Following your comments on the proposed Y Bryn Wind Farm, which were included within Appendix 1 of the EIA Scoping Direction (dated 08/03/21), please find below our response to your queries (shown in blue) which were raised in relation to the Landscape and Visual chapter of the Environmental Statement (ES).

A3.3.25 SWANSEA COUNCIL RESPONSE TO LVIA CONSULTATION LETTER - OCTOBER

A3.3.33 WHITE CONSULTANTS (REPRESENTING NPTCBC) RESPONSE TO LVIA
CONSULTATION LETTER NOVEMBER 2021 (RECEIVED FROM NPTCBC 8TH
MARCH 2022)

RESPONSE TO
REVISED SCHEME FOR COMMUNITY CONSULTATION
AND REVISED LANDSCAPE AND VISUAL IMPACT
ASSESSMENT METHOD

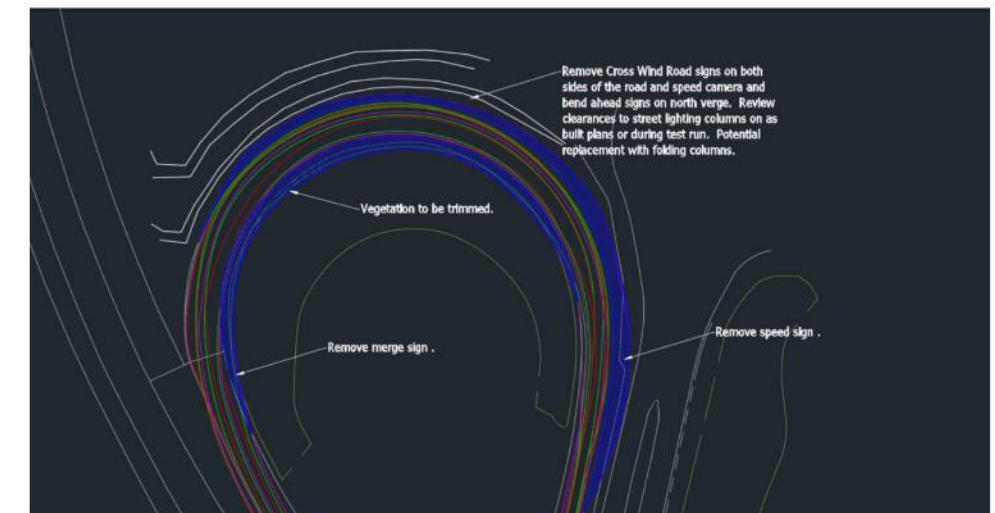
- 3) Swept Path Analysis of junction 42 – it appears from the plans provided there will be conflict between the oversail of the blade components and the rock cutting on either extent of the junction 42 on-slip.

Coriolis/ Pell Frischmann - The loads do not strike the rock face. We have revised the swept path assessment (below) to improve clearances further to the north. To the south, loads will oversail the inside of the verge requiring the movement of two road signs and trimming of vegetation.

The finalised swept path assessments and mitigation drawings will be provided upon agreement of the selected turbine and would be secured by the planning conditions noted in the WG AIL document.
